Prepared for:
Health Infrastructure NSW

Date:
25 October 2021

Submissions and Amendment Report (SSD-10349252)

Paediatric Services Building The Children's Hospital at Westmead

Figure 2 Amended Level 07 Proposed Plan.
The northern and southern wings have been squared out.
Source: Billard Leece Partnership Architects

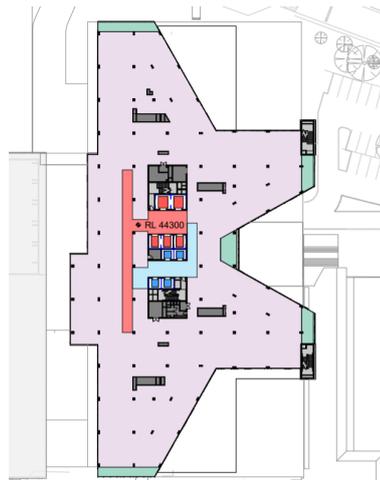
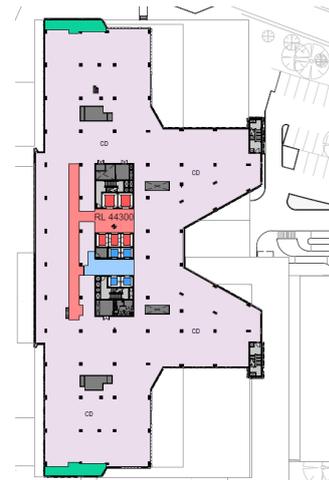
The proposed building height, site layout and design scheme remain generally unchanged from what was originally proposed and exhibited. However, the amended proposed development seeks consent for a minor change to the building footprint and subsequent increase in gross floor area (GFA), as a result of squaring out the northern and southern wings of Level 07 to match the squared-out floor plan and shape of Level 01 to Level 06. Refer to **Figure 1** and **Figure 2**. As noted previously the driver of this design change was to meet clinical requirements, in this instance for critical overnight beds.

This has resulted in changes to the GFA at Level 07, increasing by 122 sqm from 4,282 sqm to 4404 sqm. It is noted that there have been further changes to the GFA at other levels of the PSB; however, these have not resulted in any change to the building footprint. Refer to Table 5 for a summary of GFA changes by level.

Figure 3 Classification of wind safety at 1.5m above local ground level – external terraces/courtyards
Source: Arup

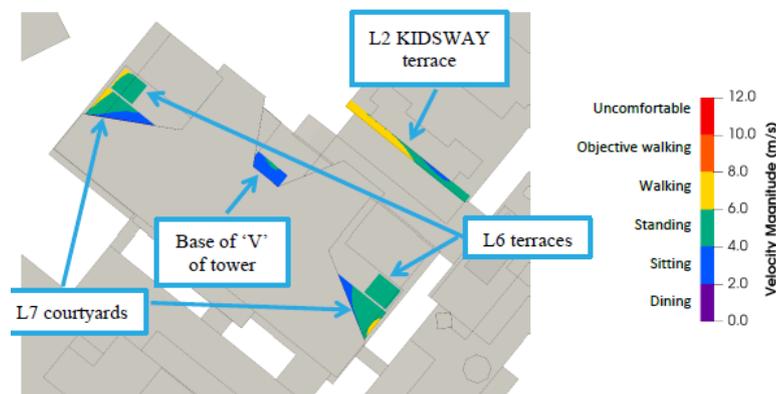
Further detail was requested in relation to the pedestrian comfort levels for the landscape terrace spaces at the PSB. As such, further wind testing was undertaken by Arup to assess pedestrian comfort and safety for the PSB at the following locations:

It is concluded that from a comfort perspective, all terraces/courtyards of the PSB are classified as suitable for walking or better, with the majority of areas classified as standing or sitting (refer to **Figure 3** and **Figure 4**). Hence, the safety criterion is met for all terraces/courtyards.

Figure 6 Level 2 floor plan for the PSB and Block 5.
Source: BLP

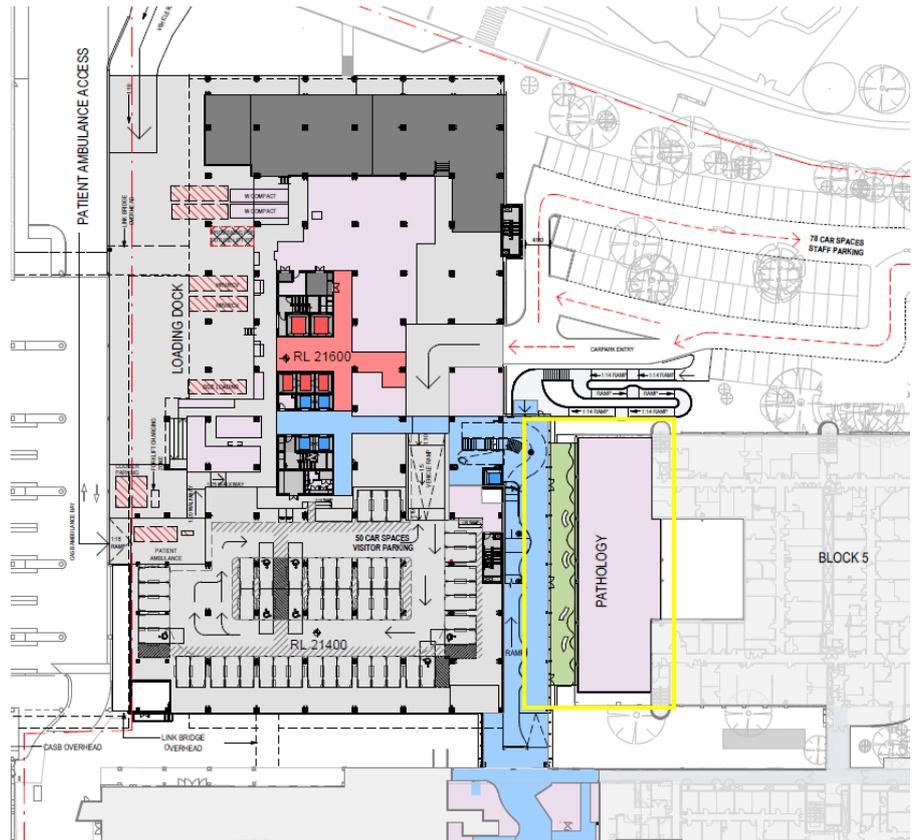
As part of the application, the existing pathology department located within Block 5 is proposed to be refurbished. The current GFA occupied by the Pathology department is

3,400 sqm and this will be expanded by 569 sqm through the enclosure of an existing terrace.

The expansion will improve efficiencies across the existing hospital and provide updated technology and processes to support the PSB. The expansion will involve infill masonry walls and infill roof slab within the existing concrete frame and so there will be no increase to the overall envelope compared to the existing pathology use, and therefore overshadowing and solar impacts remain the same as currently.

In summary, given the expansion does not modify the use and is accommodated entirely within the footprint an existing building, it is not anticipated that there will be any additional environmental impacts compared to the current situation. The revised Architectural Plans at **Attachment A** have been revised to clearly mark the location of the pathology use. The materiality of the pathology extension will be the same as the existing pathology department. This consists infill walls with render finish and slot windows to the existing pathology building concrete structural frame. Refer to drawings CHW-AR-DG-PSB-SSD030 and CHW-AR-DG-PSB-SSD03 and **Figure 5**.

Figure 11 Study of the PSB podium (Levels 04 and below) with the revised external colour scheme
 Source: Billard Leece Partnership Architects

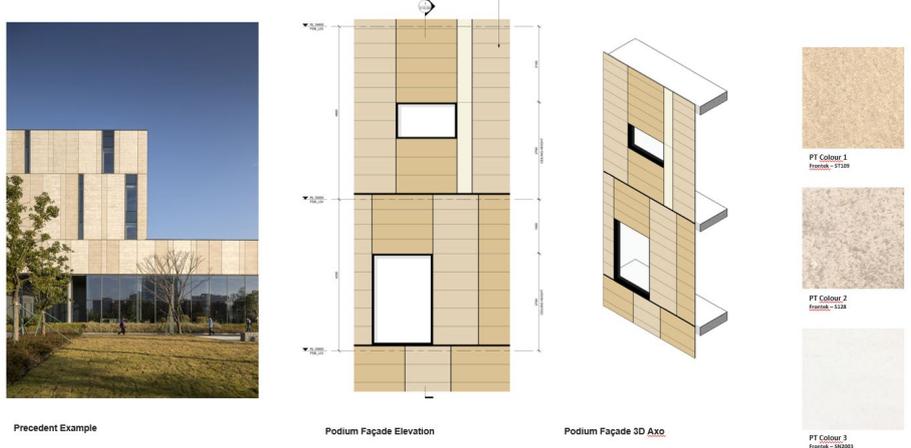
The external colour scheme of the PSB has been revised with further consideration of the original design's river narrative. The intent is to ground the PSB in its context with the Parramatta River, Toongabbie Creek and surrounds, and to embody its 'Connection to Country' through use of natural colours and textures.

The building design comprises two main features, a tower and a podium, separated from each other by a recessed plant level on Level 5. The revised tower design draws inspiration from the texture and play of light across the surface of the river (**Figure 8** and **Figure 9**), while the podium provides a strong foundation, with references to geological stratification, colours and textures (and).

Figure 14 Northeast Elevation – External building identification signage zones
Source: Billard Leece Partnership Architects

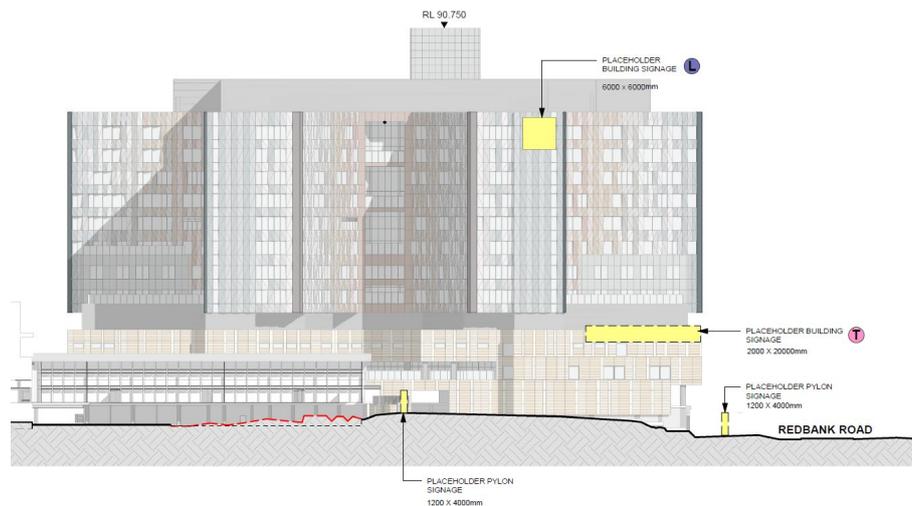
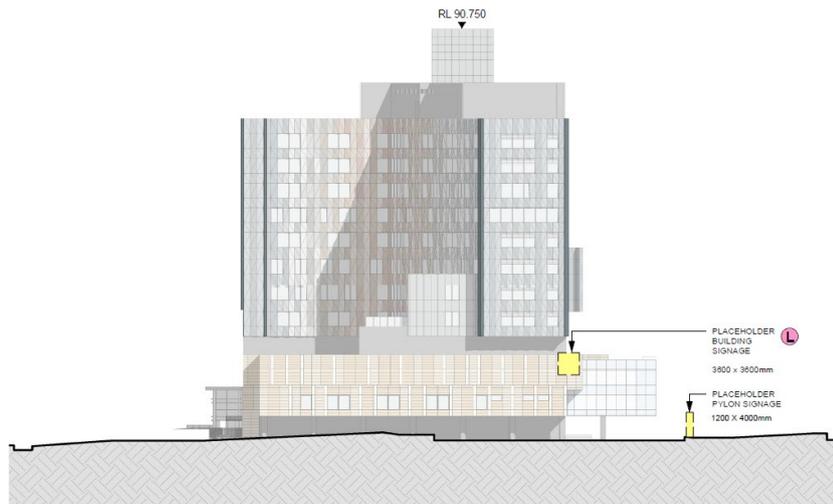
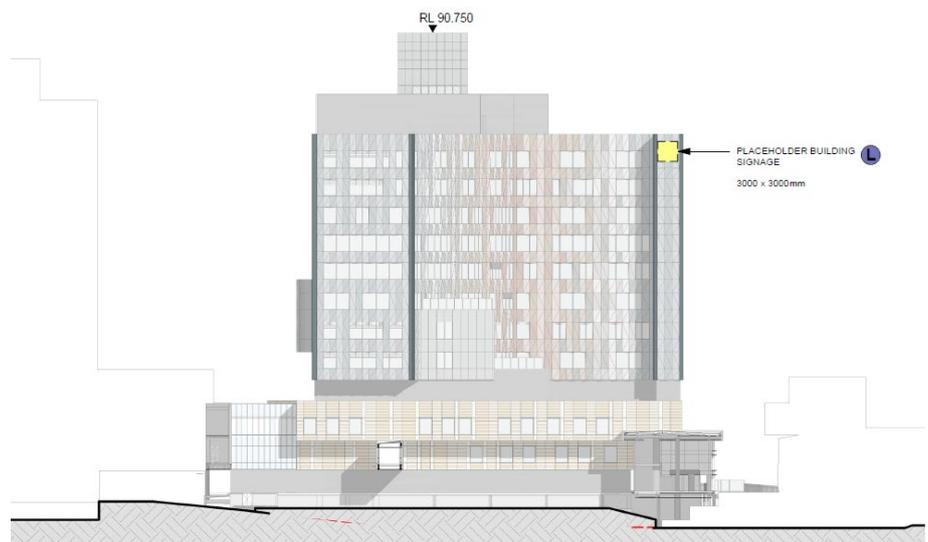
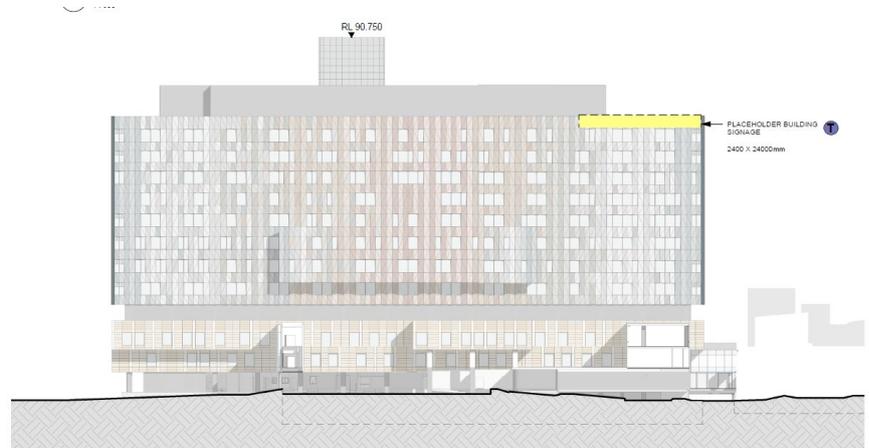
The revised Architectural Plans prepared by Billard Leece Partnership Architects (**Attachment A**) show building identification signage “zones”. Refer to extracts at **Figure 14** to **Figure 15**.

- North-east elevation: placeholder building signage 6000 x 6000
- North-east elevation: placeholder building signage 3000 x 21000
- North-west elevation: placeholder building signage 3600 x 3600
- North-east elevation: placeholder building signage 3000 x 3000
- South-west elevation: placeholder building signage 2400 x 24000”
